Time to take a stand – the proposed new Ben More hydro track

Address: Benmore Farm Crianlarich Stirling FK20 8QS

Proposal: Construction of a run of river hydropower scheme

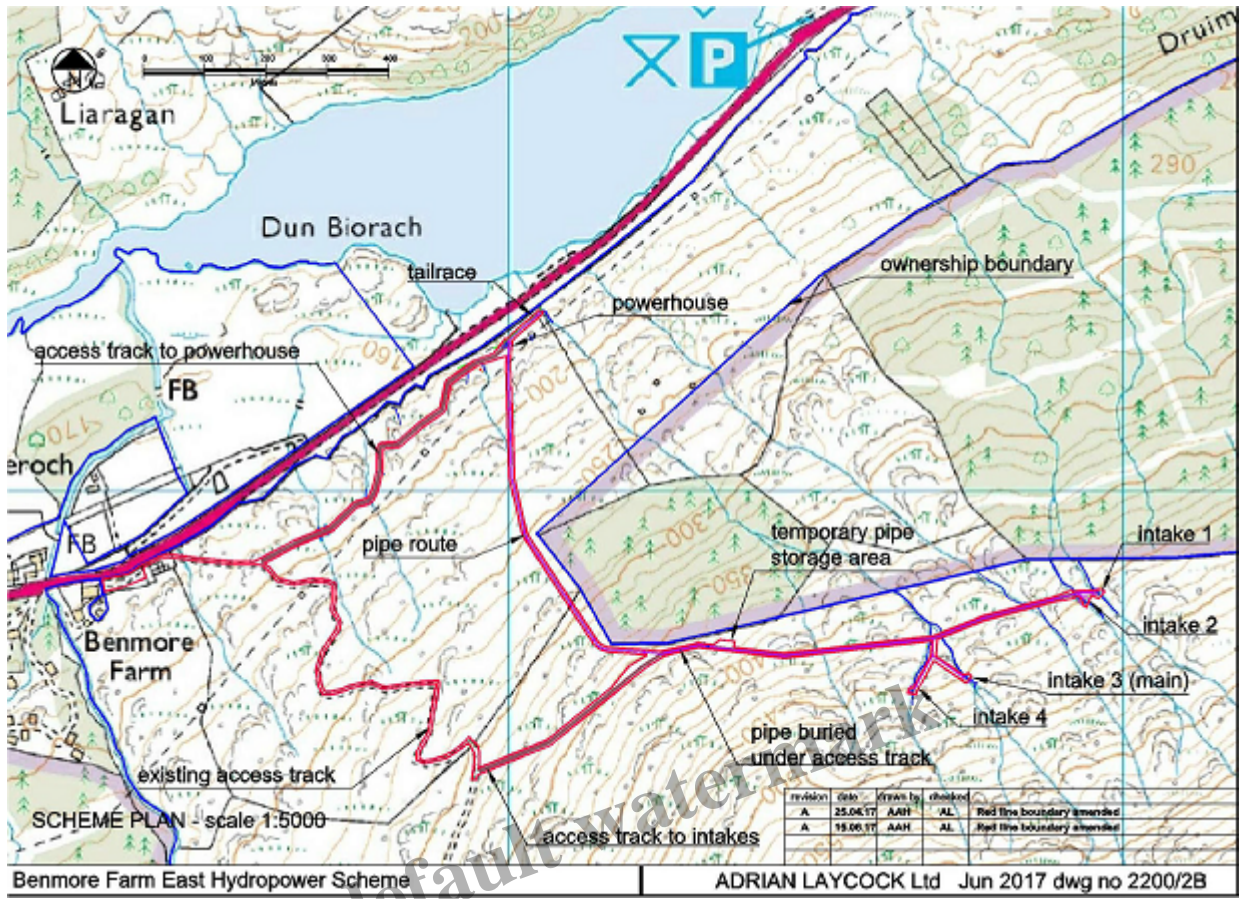
When you approach the intake though the most obvious feature is the metal fencing – contrary to Park guidance on use of natural materials (but is it really necessary?) – and the Lomond blue pipe. Its a shame that the left side of the intake has not been finished like the right had side but it does show, I think, what can be done. Well done somebody!

The recovery of the ground above the pipeline and construction track is not as good as it might have been because vehicles have been driven over land which is far too wet to support them.
